PLANNING, ZONING, & BUILDING DEPARTMENT
PZ&B Staff Combination Memorandum: Architectural Commission and Town Council

SUBJECT: ARC-23-074 (ZON-23-061) 100 WORTH AVE (COMBO)

MEETING: JUNE 28, 2023 ARCOM
JULY 12, 2023, TC

ORIGINAL SITE PLAN

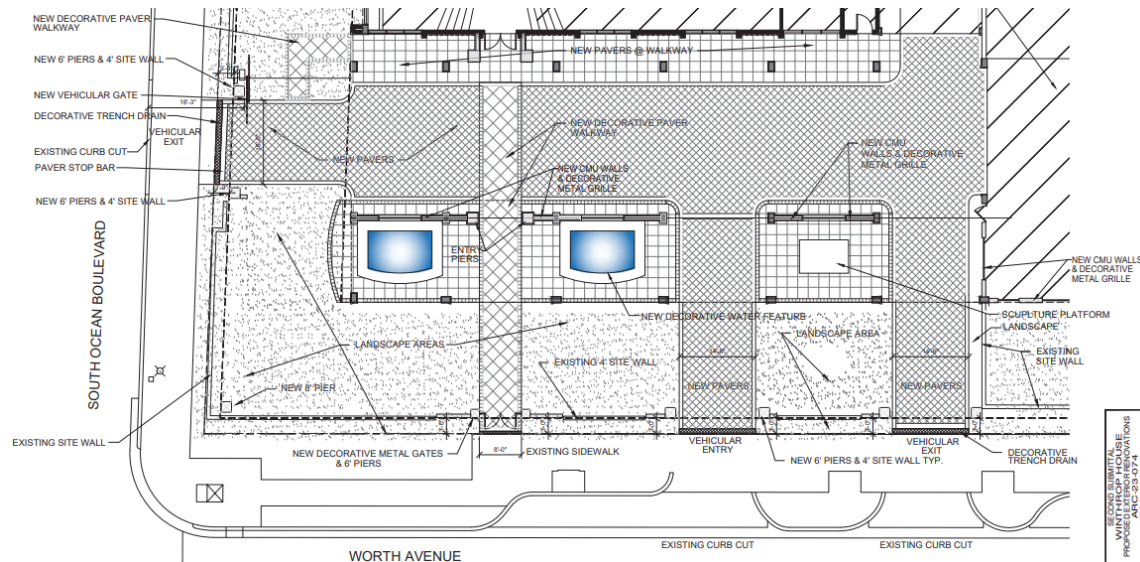
The request for the variance relief is to improve the existing Front Yard Landscape Open Space conditions along Worth Avenue and South Ocean Boulevard by removing hardscape and what appears to be non-conforming partaking areas. The application proposes to replace those areas with natural landscape areas. If approved, the proposal would increase the overall Landscape Open Space by 2%, or 2,000 SF, which is not an easy achievement while working with the siteplan of an existing 8-story building built in 1970. The landscape improvements to the site will not include any vegetation greater than 30-inches within sight lines. The Public Works Department and Fire Department have reviewed the proposal, and have no outstanding issues regarding the removal of drive aisles and the installation of the vehicular gate.

The existing 8-story building is non-conforming as it pertains to the current parking requirements, and the elimination of five spaces will result in a furtherance of the non-conforming nature. The Code requires 2 spaces per unit + 1 per 5 for guests, for a total of: 121 units x 2 = 242 + 25 guest spots = 267. Currently, the site has the original 251 spaces it was constructed with.

PROPOSED SITE PLAN

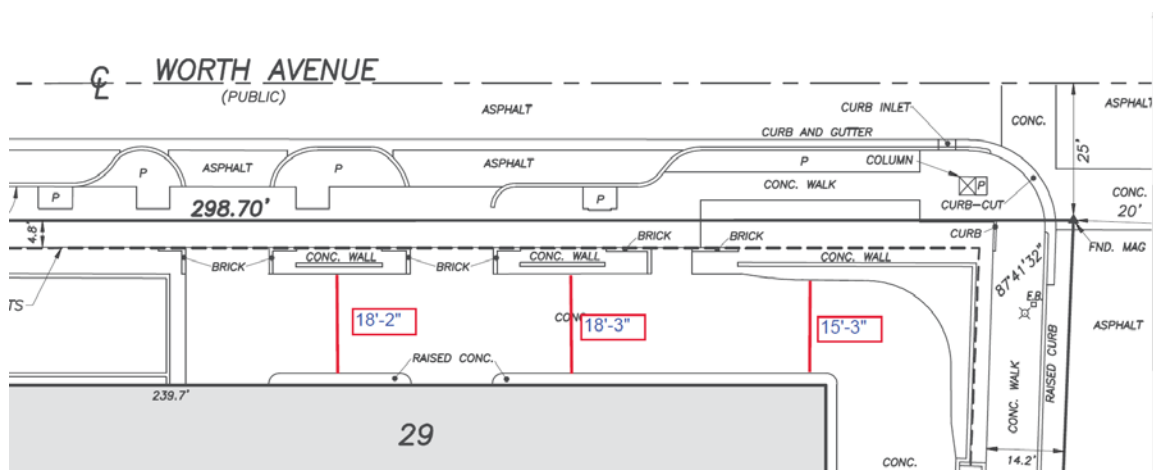
A careful review of the existing conditions, which included a field visit, confirms that the existing ‘parking’ area, or the hardscape area along the southeast corner of the subject property, does not have sufficient width to provide both a one-way drive aisle (12’) and parallel parking space (10’) which is what the existing conditions recite. As such, to retain the existing conditions, albeit with a new ground hardscape material, would trigger variances that would be in contravention to life safety as it pertains to vehicular traffic flow.

Staff does have some concerns that the area does provide an adequate temporary loading and delivery space for the building. The applicant maintains that the site is currently overparked and that the 246 spaces that will remain is more than adequate for the needs of the building.
